ADDENDUM #2

Project Name:
Newton Correctional IPI Homes for Iowa Phase II - Fencing
DAS Project # 9239.04
RFB 923904-02
Addendum #2
Dated: July 24, 2026

Addendum

Owner:	State of Iowa
Project Name:	Newton CF IPI Homes for Iowa Fence
A/E Project Number:	02401959.001
Owner Project No.:	9239.04
Owner Request for Bid	RFB 923904-02

C2.1

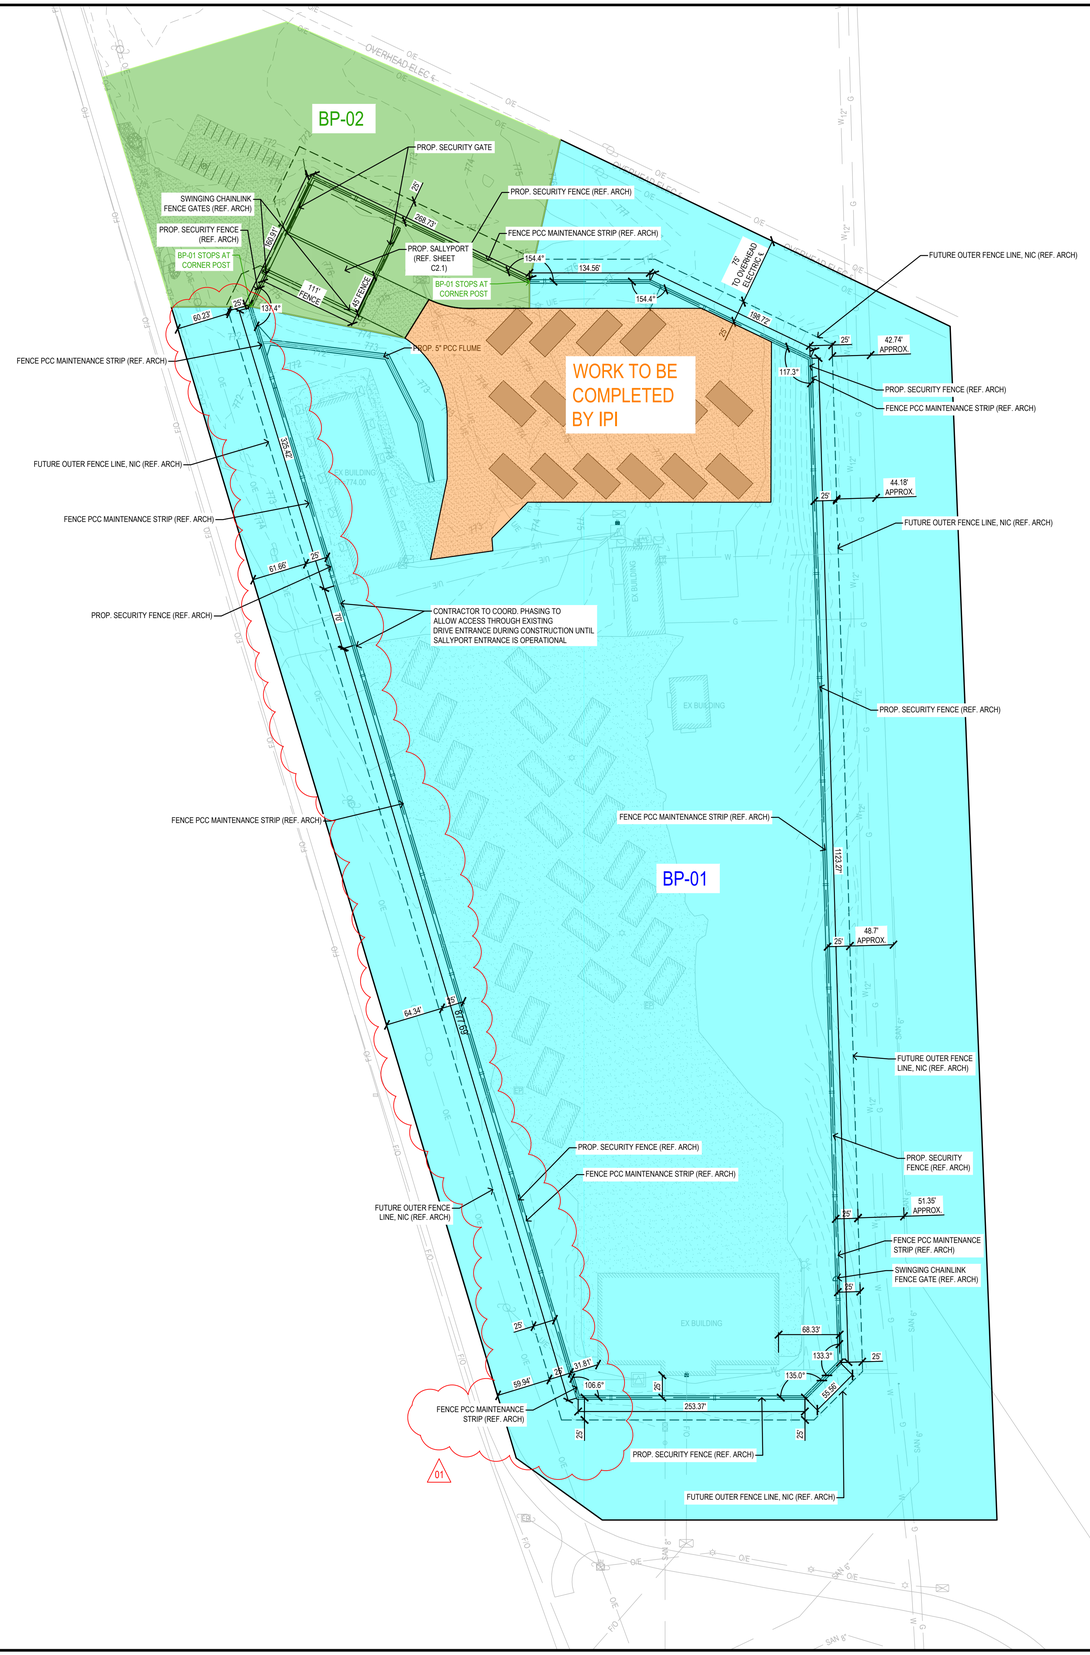
Item No. 4 Slight Adjustment to fence routing adding an additional 6 feet of fence and associated maintenance strip.

Item No. 5 Note added for contractor to ensure that fences are to be constructed a minimum of 25’ off of buildings.

SHEET NUMBER:
C3.1

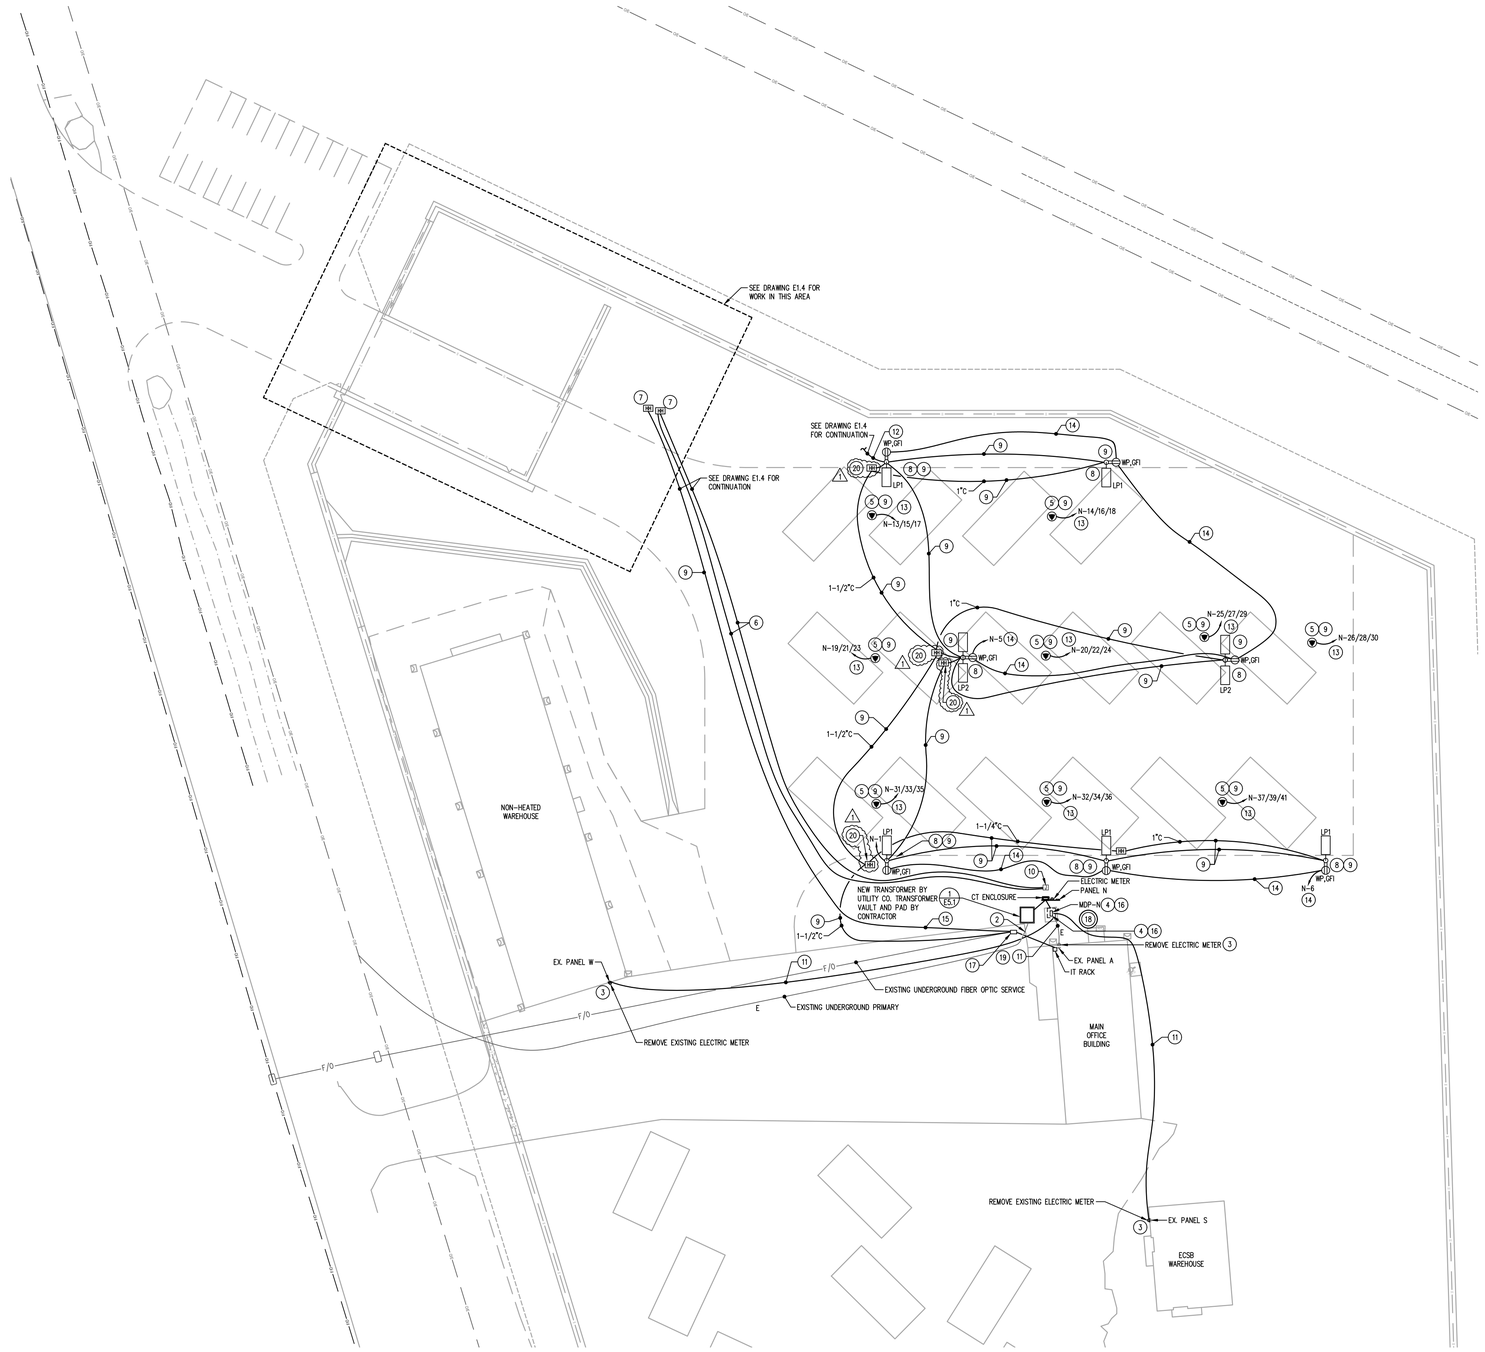
Item No. 6 Slight shift to spot grades where fence had minor location adjustment.

SHEET NUMBER:
E1.2

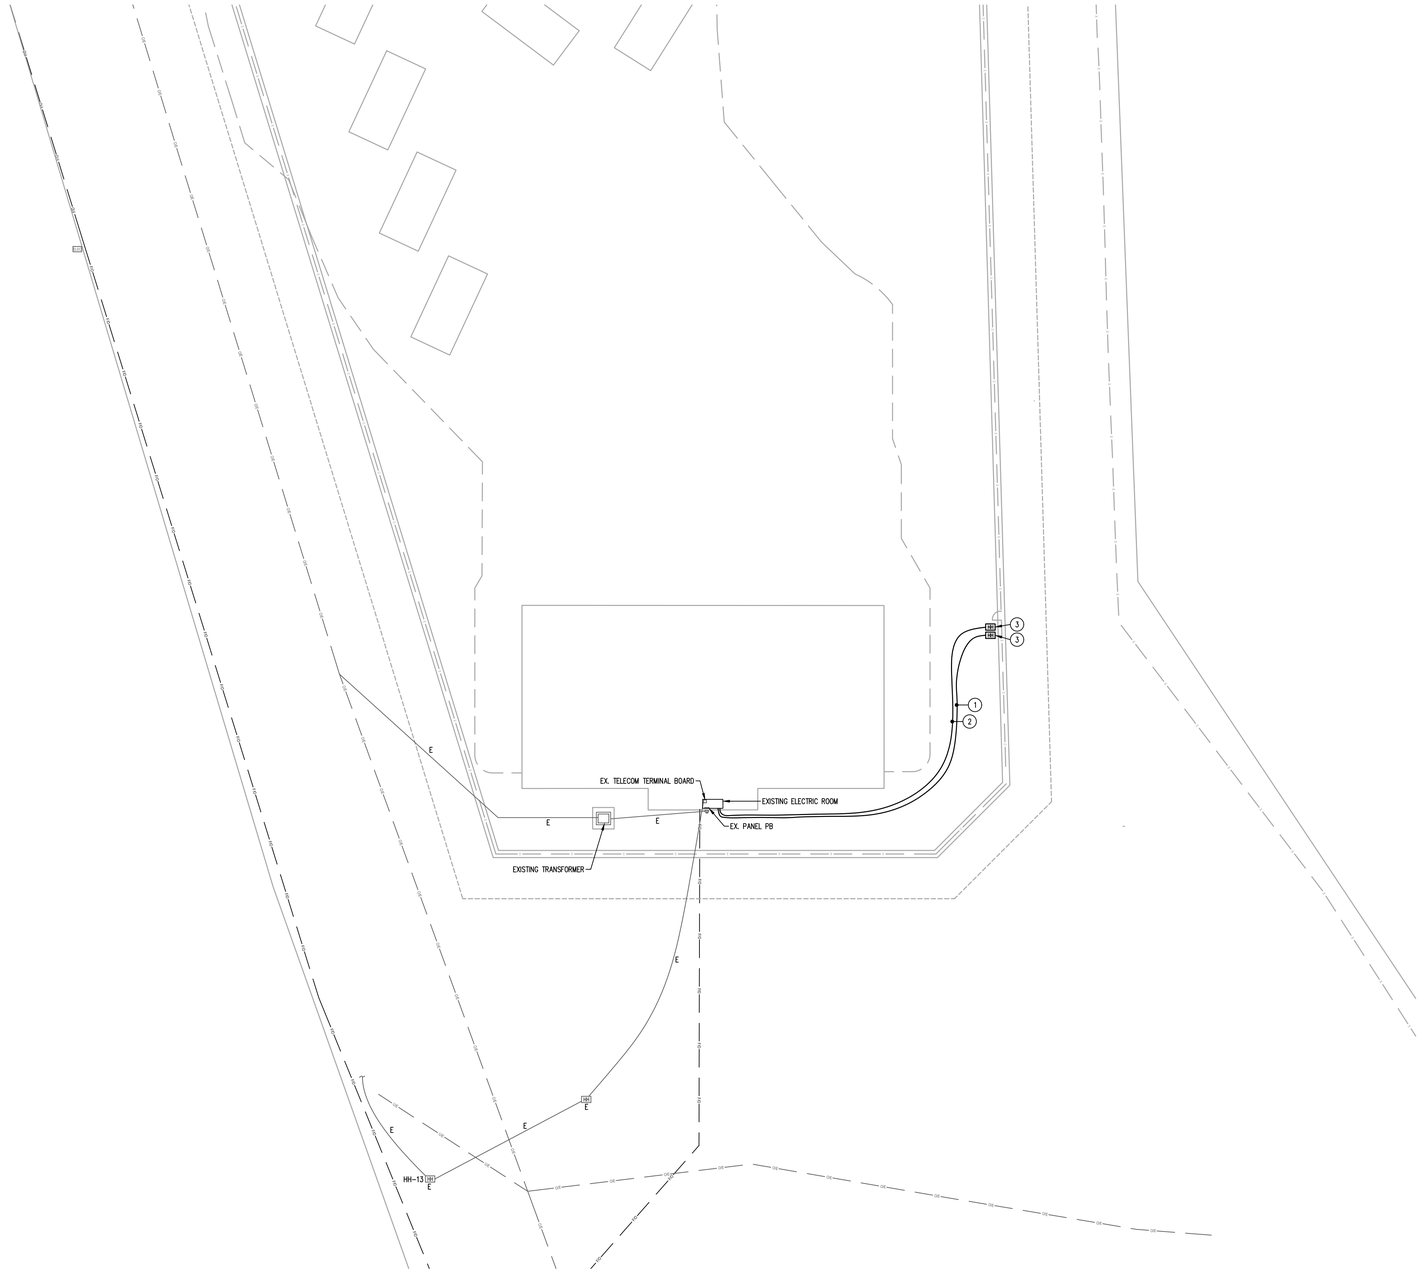
Item No. 7 Add Keyed Note #20 and note references for existing hand holes as shown on revised drawing E1.2.

SHEET NUMBER:
E1.3

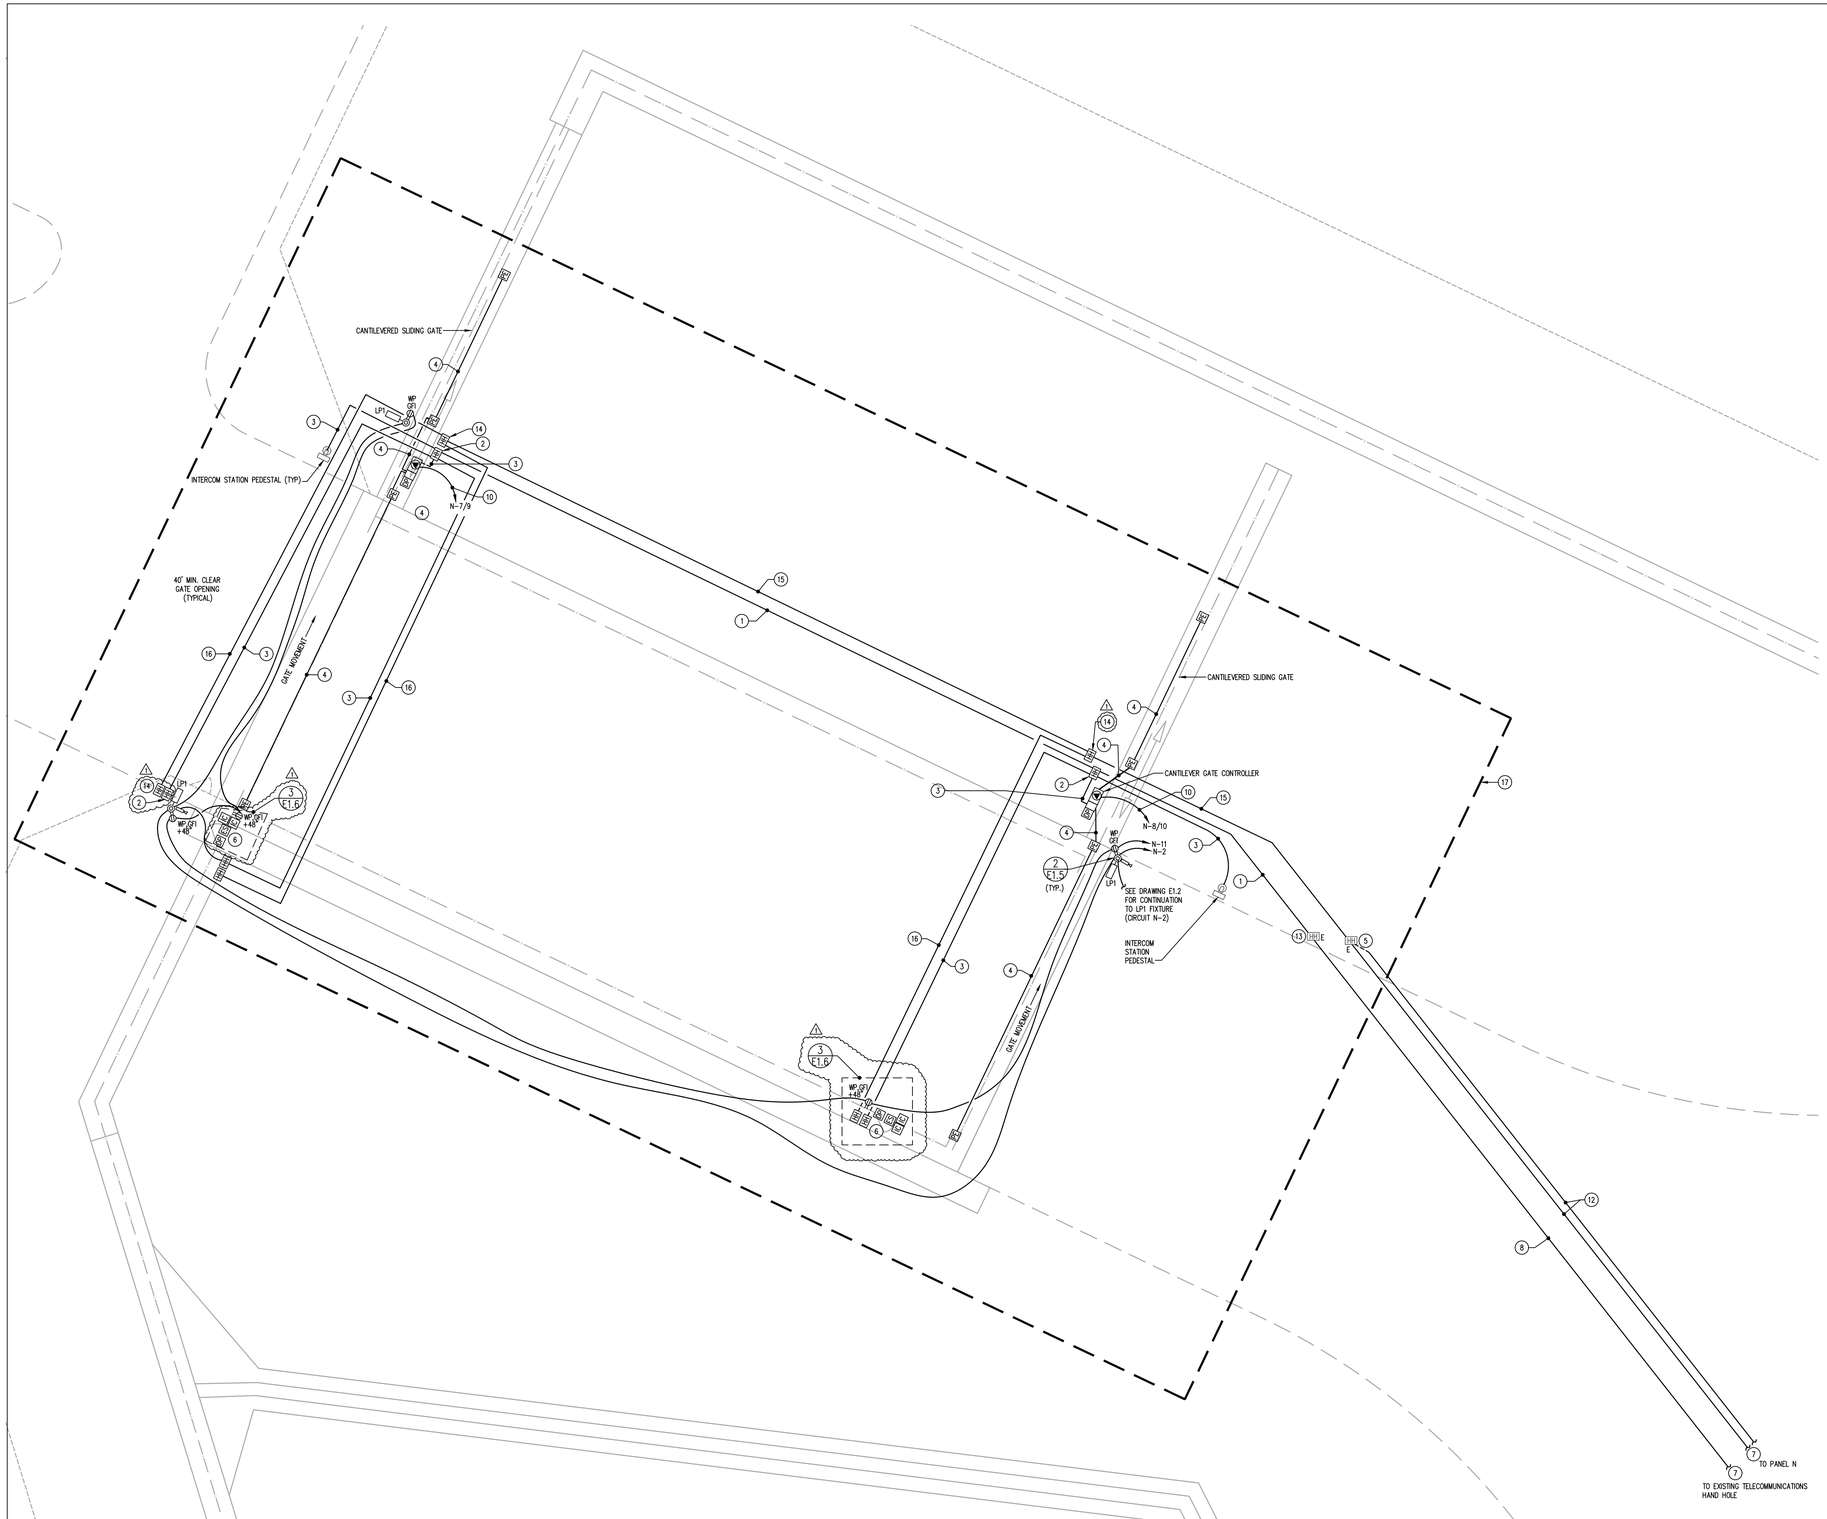
Item No. 8 Revise Keyed Note #3 as shown on revised drawing E1.3.

1 E1.6 POWER PEDESTAL DETAIL (ALTERNATE BID 3)

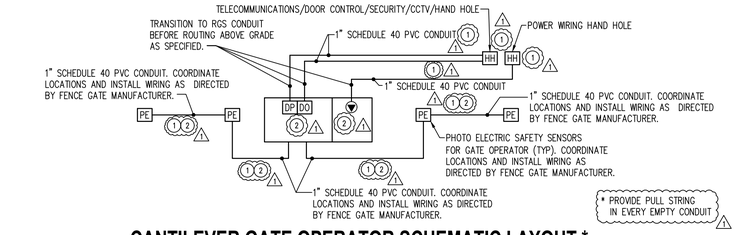
Item No. 13 Revise Detail 3/E1.6 for Fence Gate Schematic Layout as shown on revised drawing E1.6.

2 E1.6 CANTILEVER GATE OPERATOR SCHEMATIC LAYOUT *

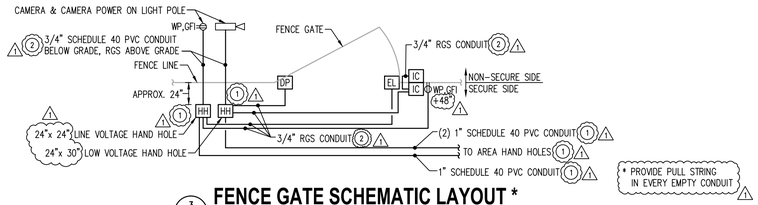
Item No. 12 Revise Detail 2/E1.6 for Cantilever Gate as shown on revised drawing E1.6.
